REMARKS

Claims 1-12 were presented for examination with claims 1-3, 5-10 and 12 being rejected. Claims 4 and 11 are also identified as rejected but no grounds are stated. The drawings and specification have been objected to. This amendment amends all claims to better claim that which the applicant regards as the invention, adds claims 13-20, provides a new set of drawings for which approval is requested and provides a new specification. No new matter is involved.

Please amend the drawings by substituting the attached 6 replacement sheets for the original 6 sheets of drawings. The drawing changes are indicated in red in the attached Annotated Marked-up Drawings. ✓

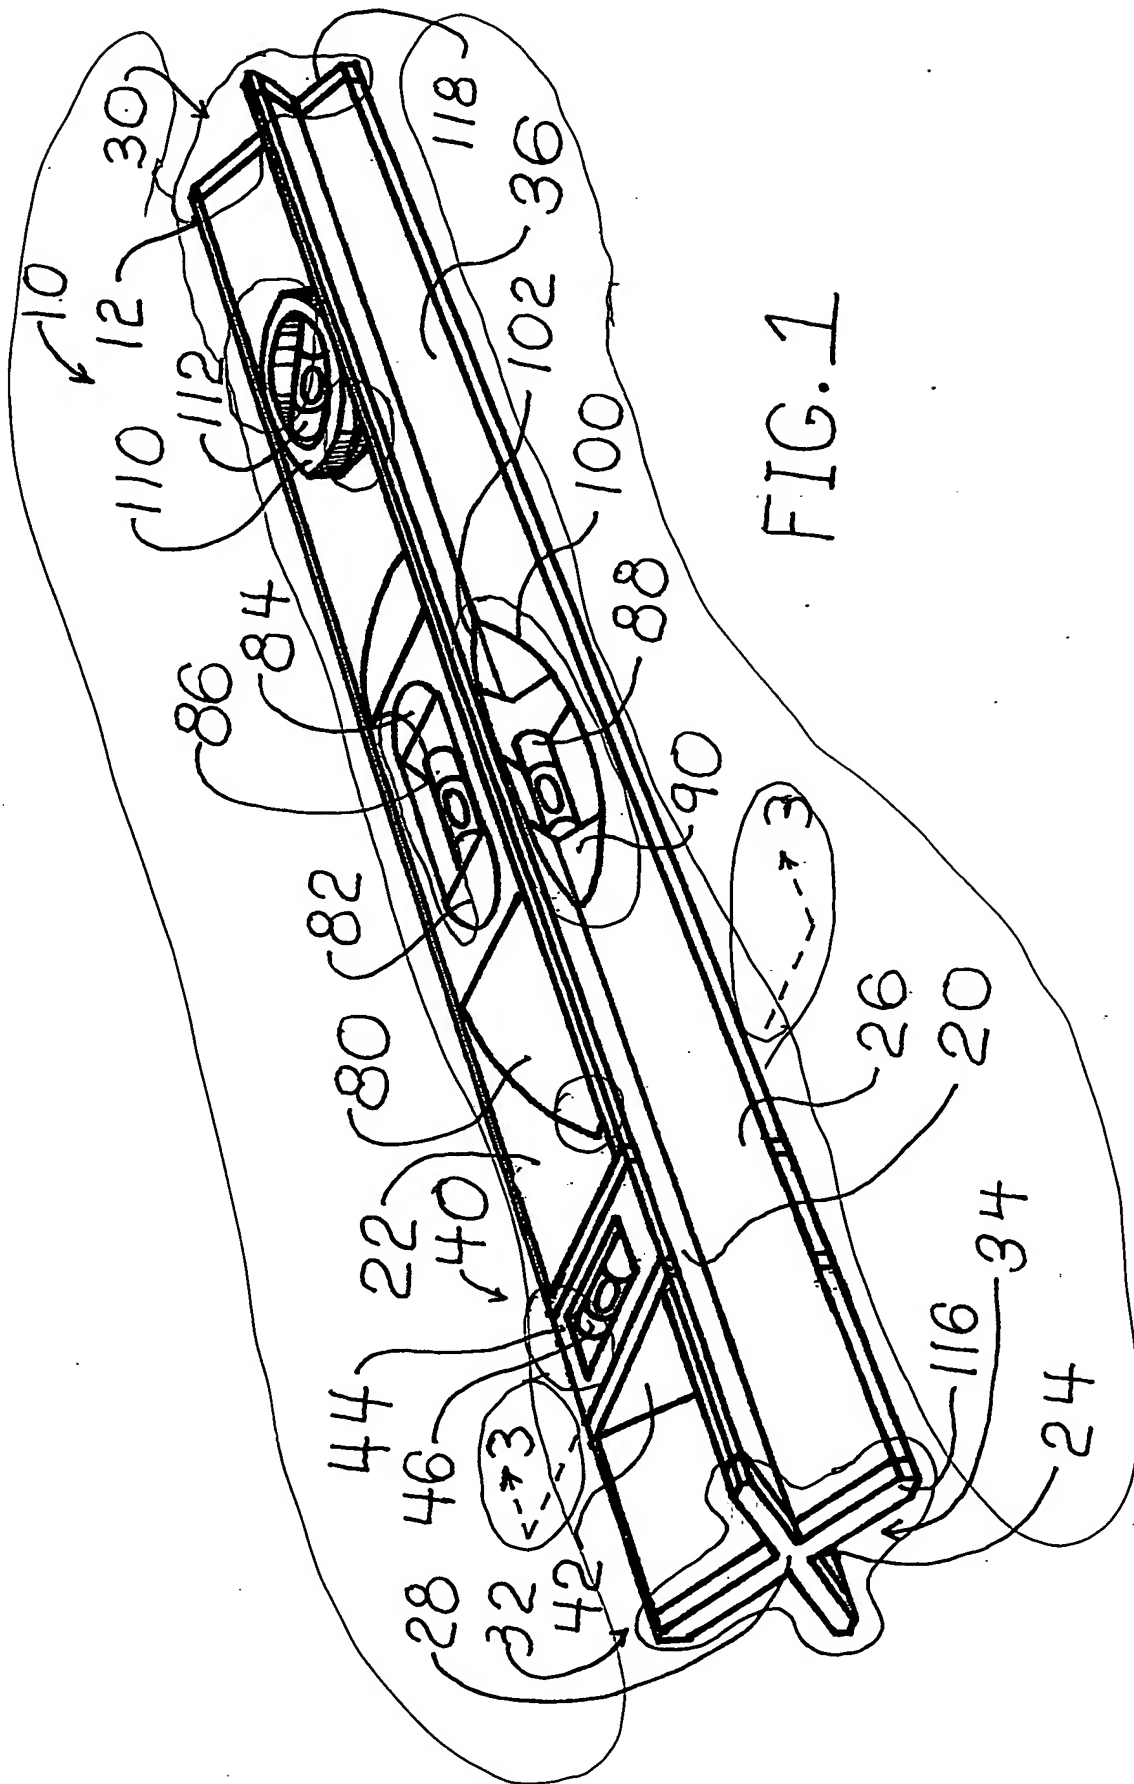
In Fig. 1 solid shading has been removed at several locations that have been encircled in red and the reference numerals have been changed to match the revised specification. Arrows have been added to illustrate the plane of the sectional view of Fig. 3.

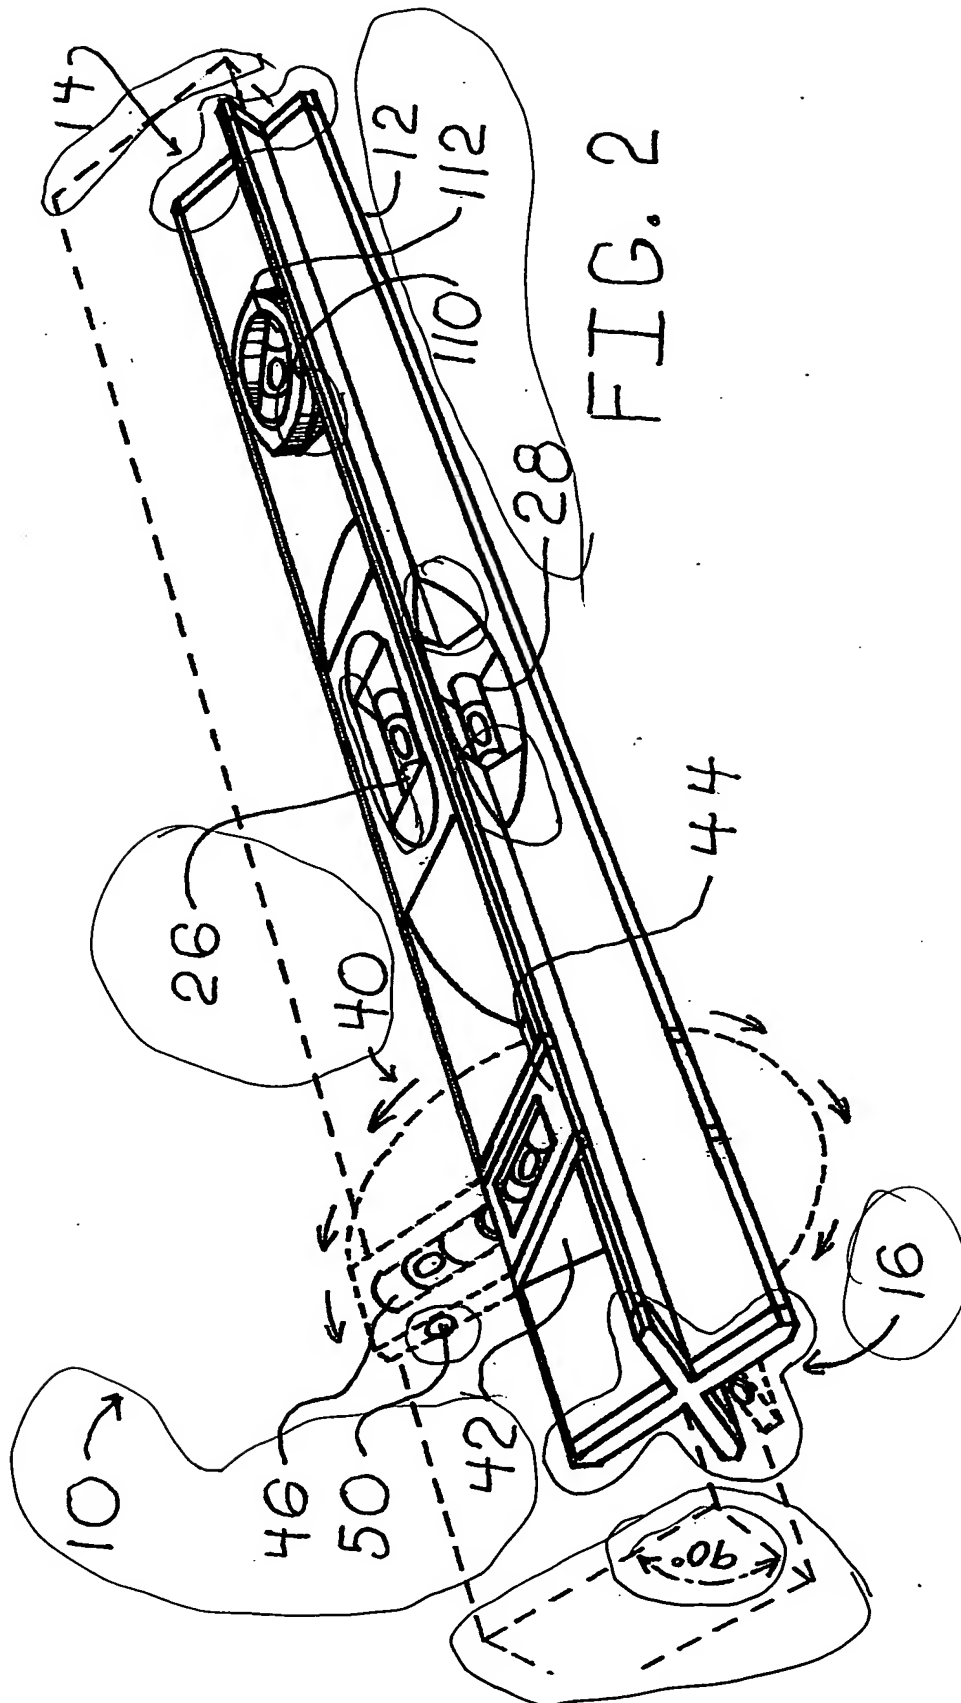
In Fig. 2 solid shading has been removed at several locations that have been encircled in red and the reference numerals have been changed to match the revised specification. The work piece has been shown in all dashed line outline, the erroneous "45-degree" indication has been corrected to --90-

degrees-- and the word "post" has been removed. The orientation of the reference numerals and figure number have been changed to provide consistence with Fig. 1.

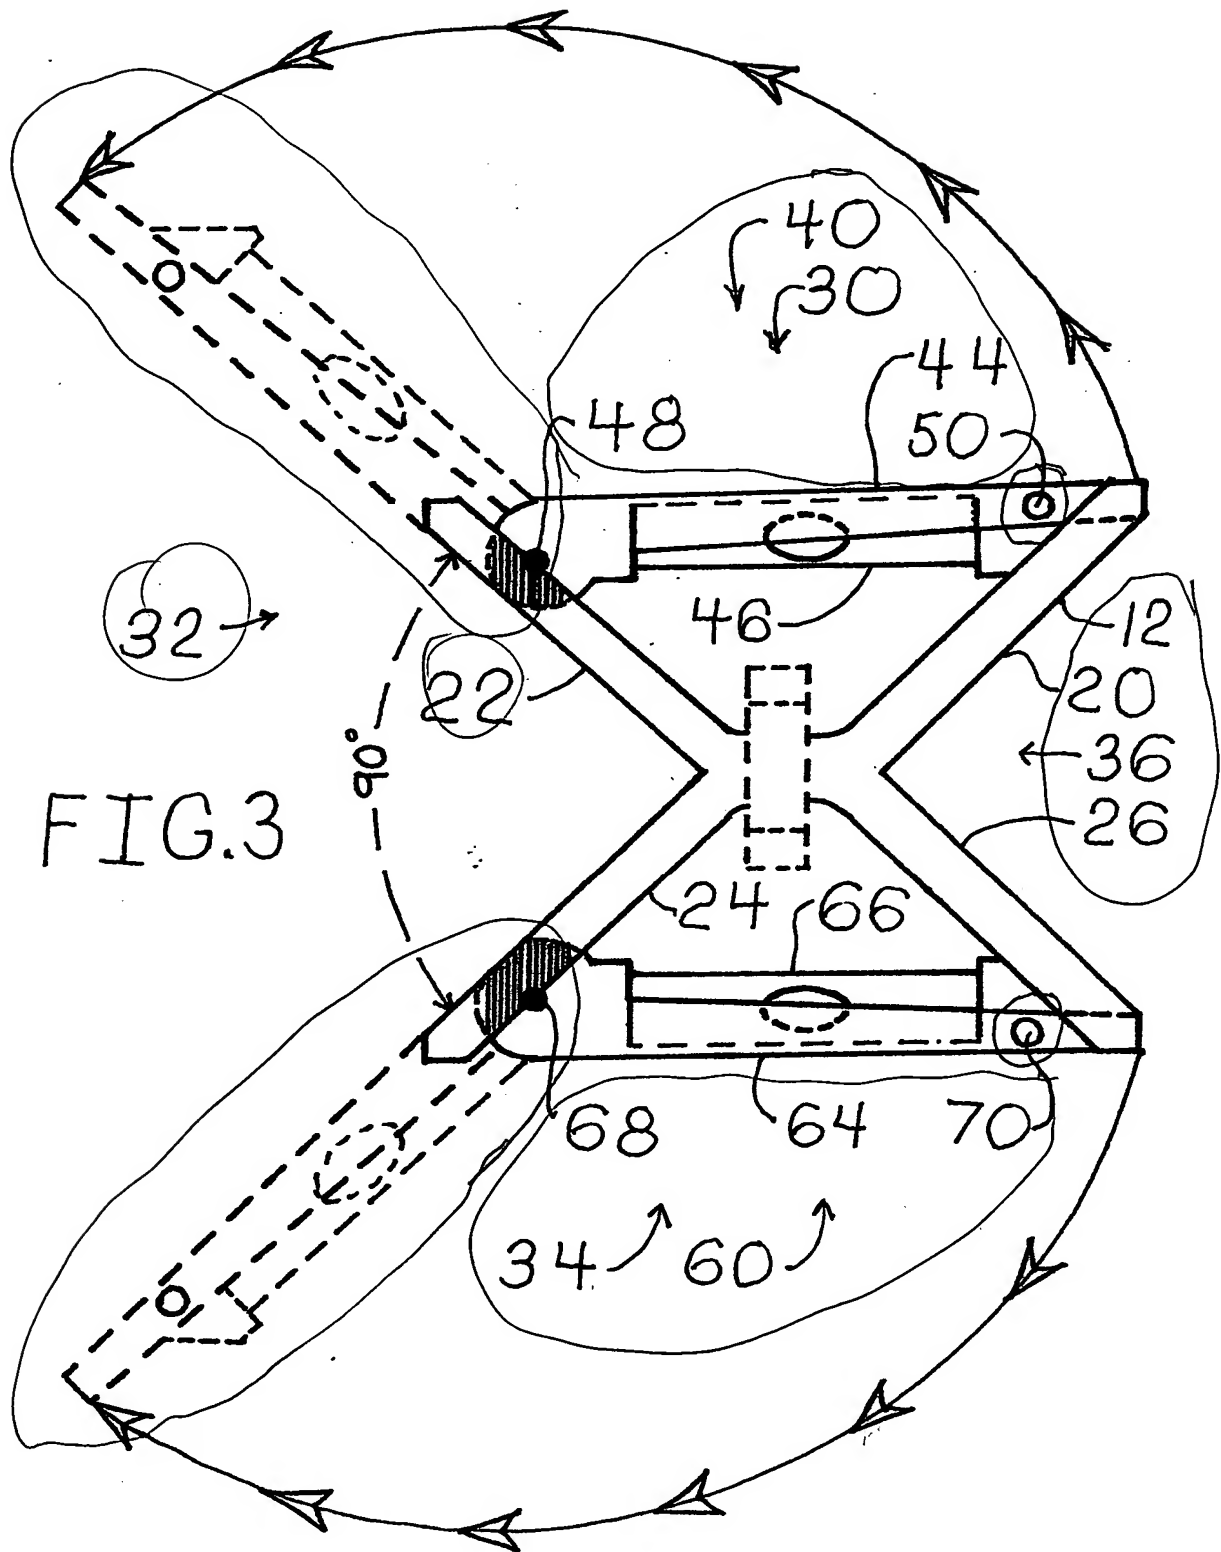
In Fig. 3 solid shading has been removed at several locations that have been encircled in red and the reference numerals have been changed to match the revised specification. The orientation has been inverted to provide consistency with Figs. 1 and 2, and alternative extended positions of the flip out brackets and bubble vials have been shown in dashed outline instead of solid outline.

FIG. 4

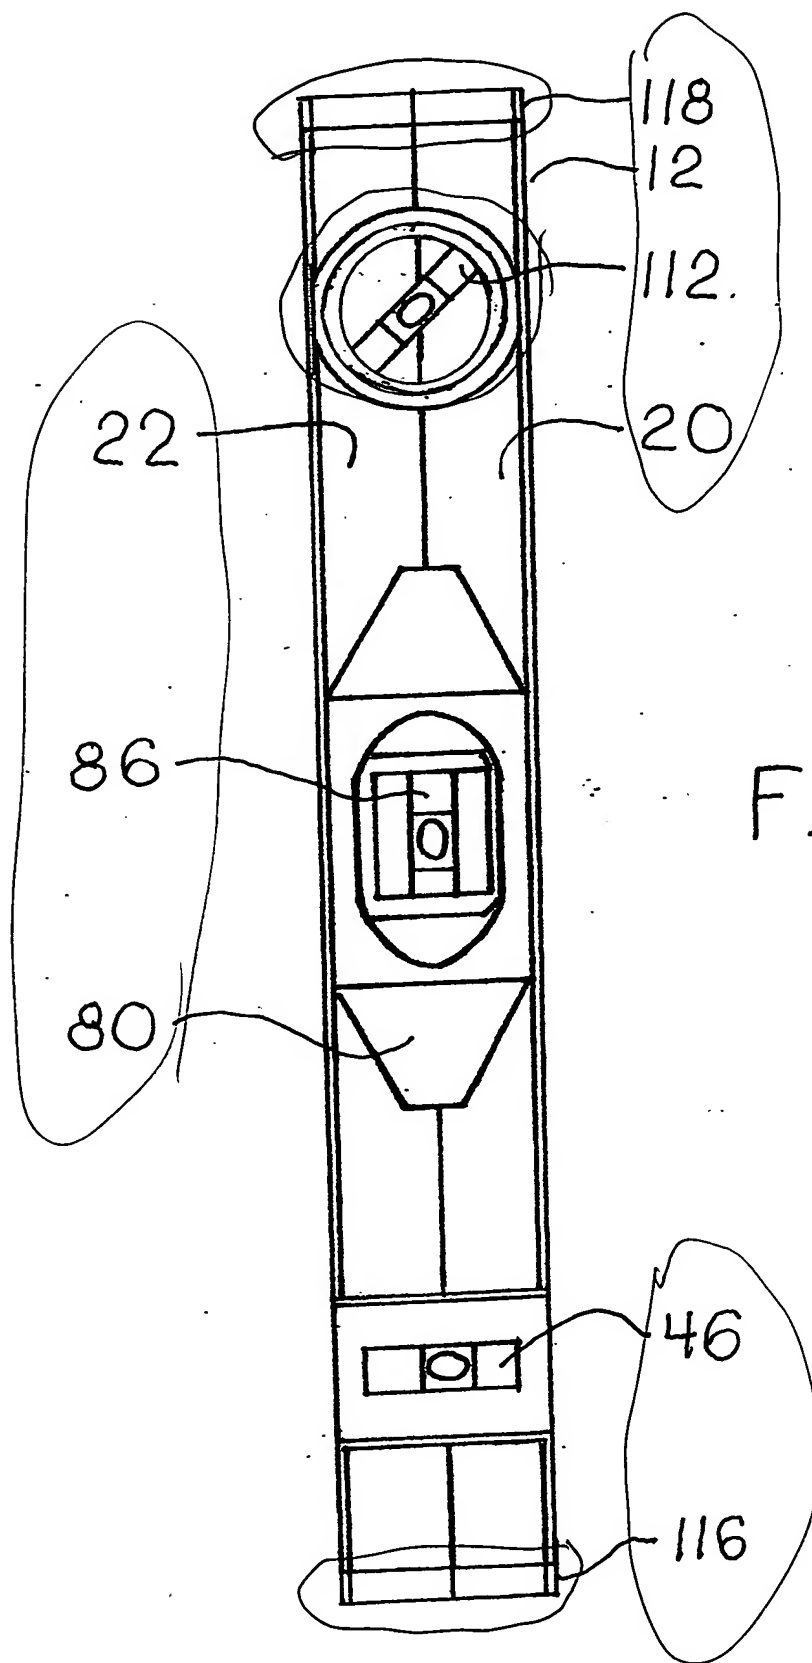
In Fig. 4 solid shading has been removed at several locations that have been encircled in red and the reference numerals have been changed to match the revised specification. The orientation has been inverted to provide consistency with Fig. 1, 2 and 3.

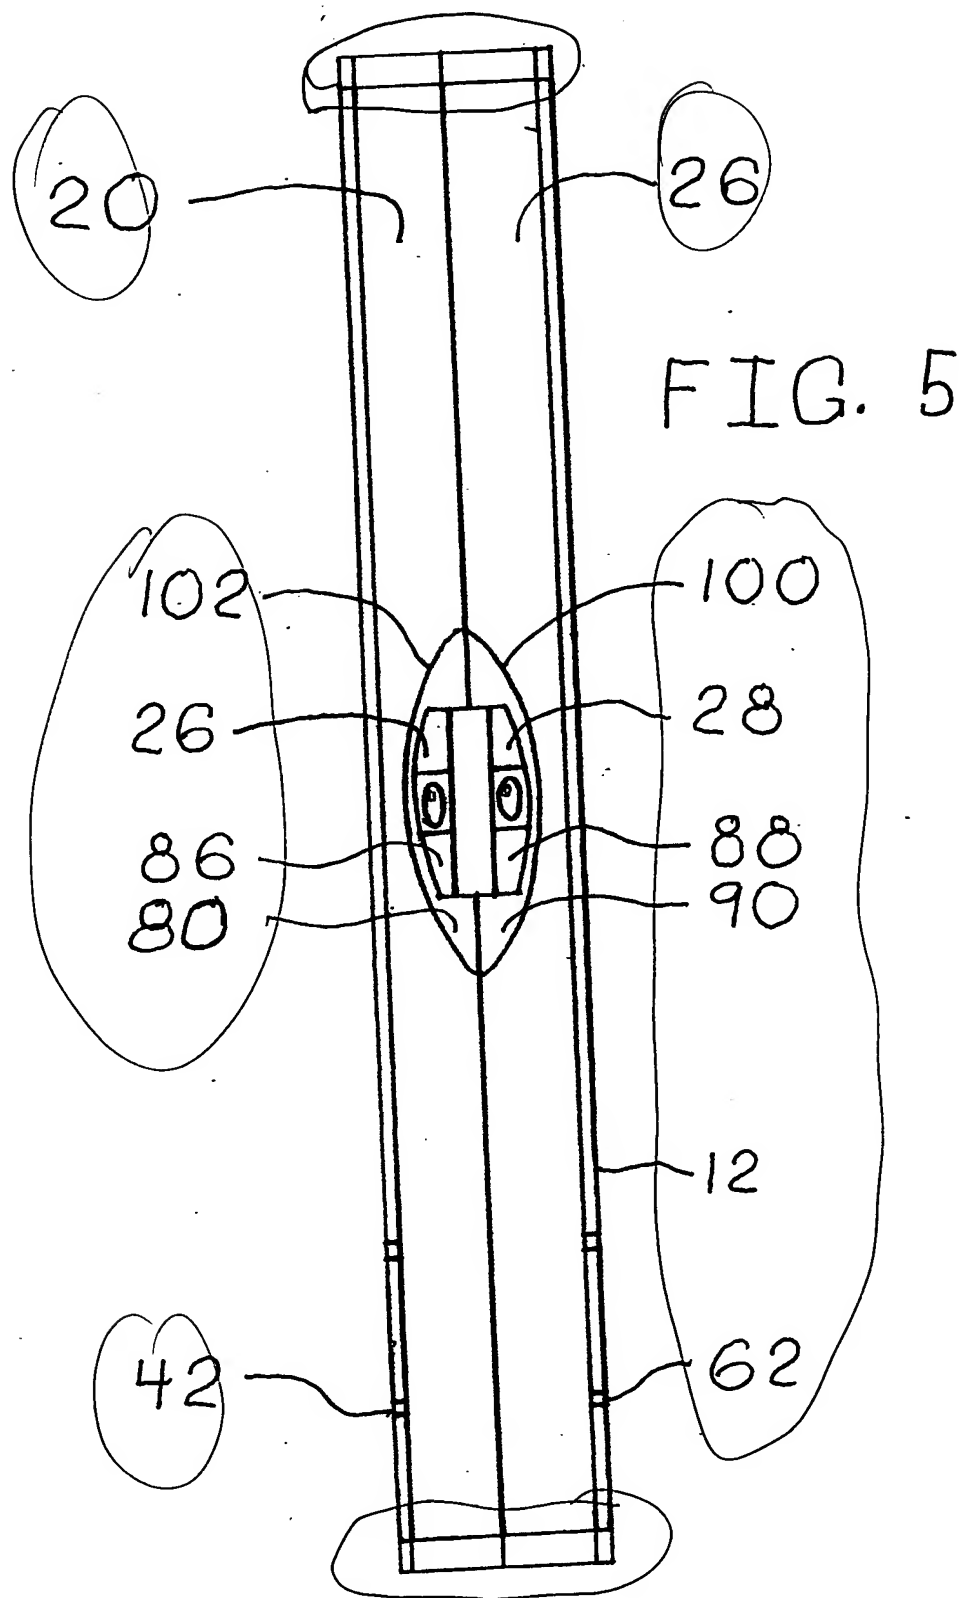
In Fig. 5 solid shading has been removed at several locations that have been encircled in red and the reference numerals have been changed to match the revised specification. The orientation has been inverted to provide consistency with Fig. 1, 2, 3 and 4.

FIG. 6

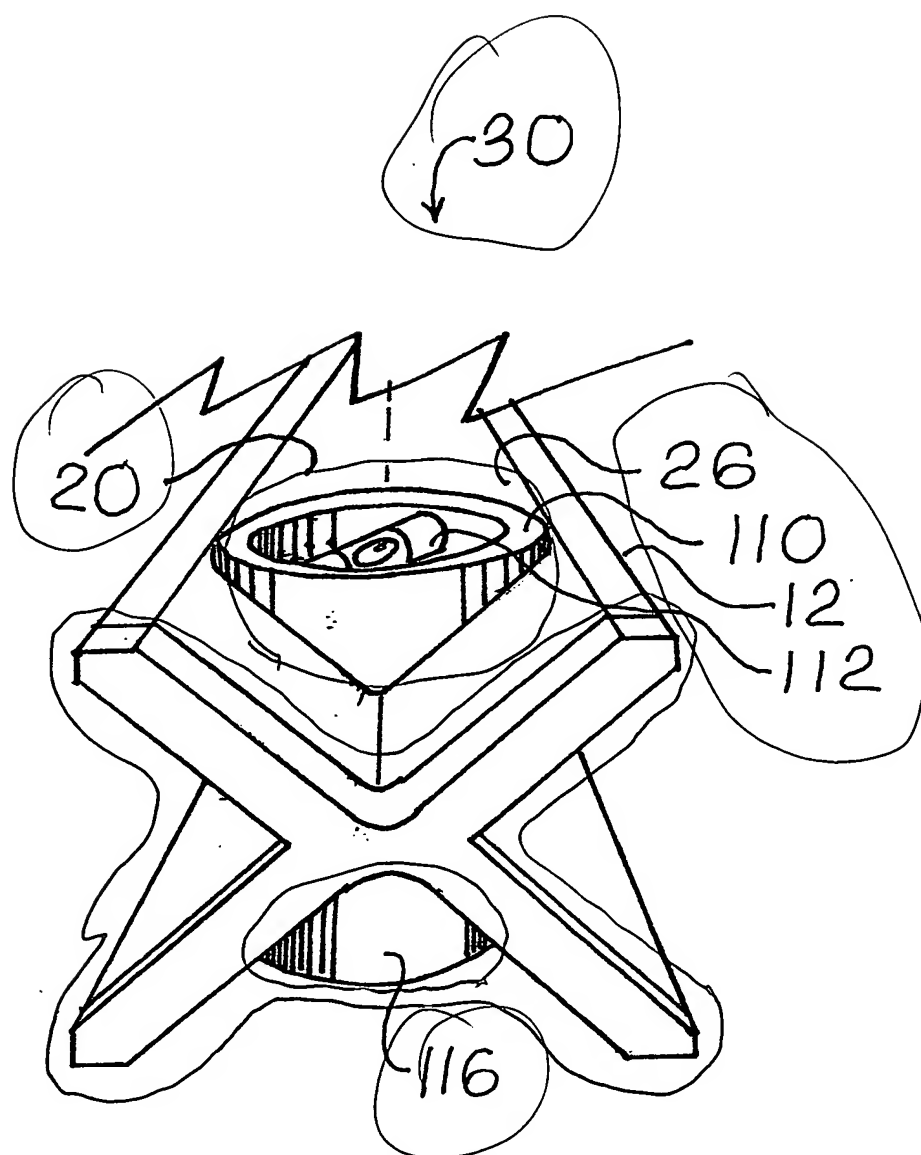
In Fig. 6 the shading has been modified as shown in red and an end cap has been shown as encircled in red for consistency with Figs. 1-5. The reference numerals have been changed to match the revised specification.
